Certificate of Appropriateness

Property	2662 N. Grant Blvd.	Grant Boulevard HD
Description of work	Rebuild and replace masonry elements of porch. On the right side, rebuild the porch using salvaged brick and reinstall the existing capstone. On the left side, tuck point as needed, replace brick as needed, replace missing/loose mortar, and reinstall existing capstone.	
Date issued	7/23/2019	PTS ID 114803 COA: masonry repairs

Right
Side

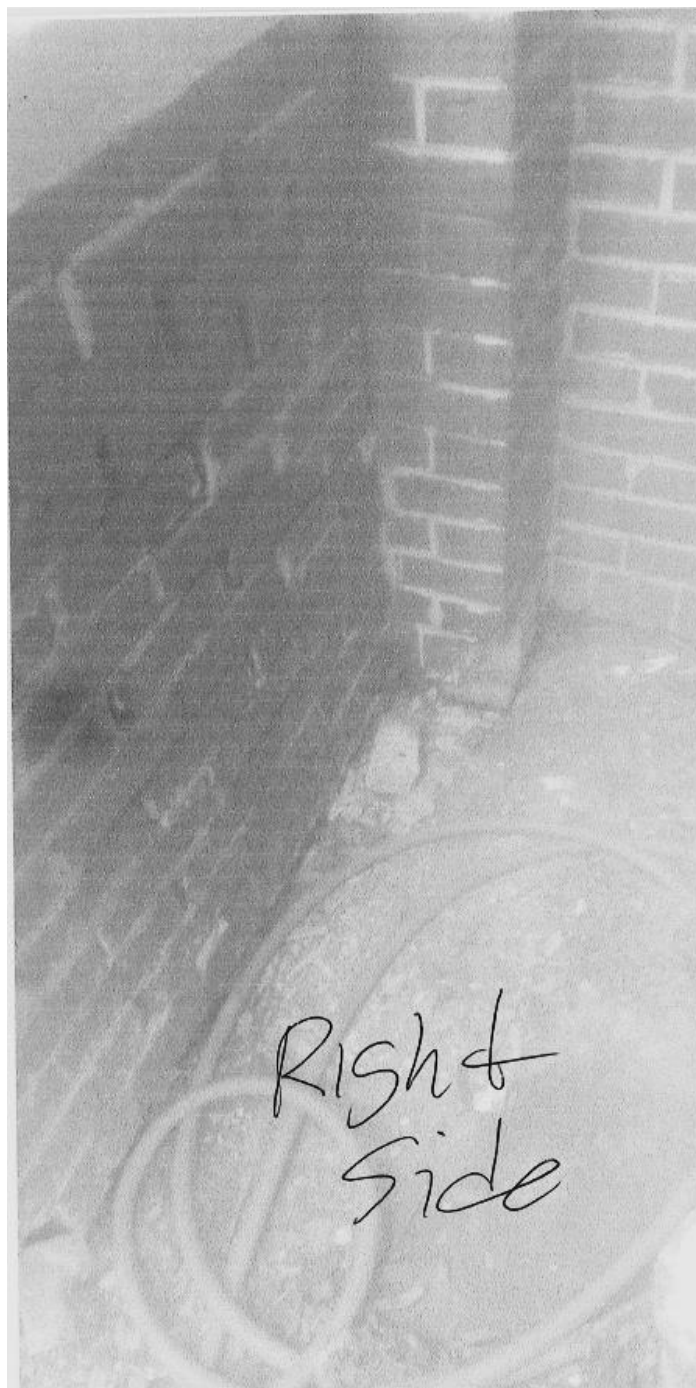
Photographs of the right side of the porch to be repaired, brick will be replaced with salvaged brick if needed, existing capstone to remain
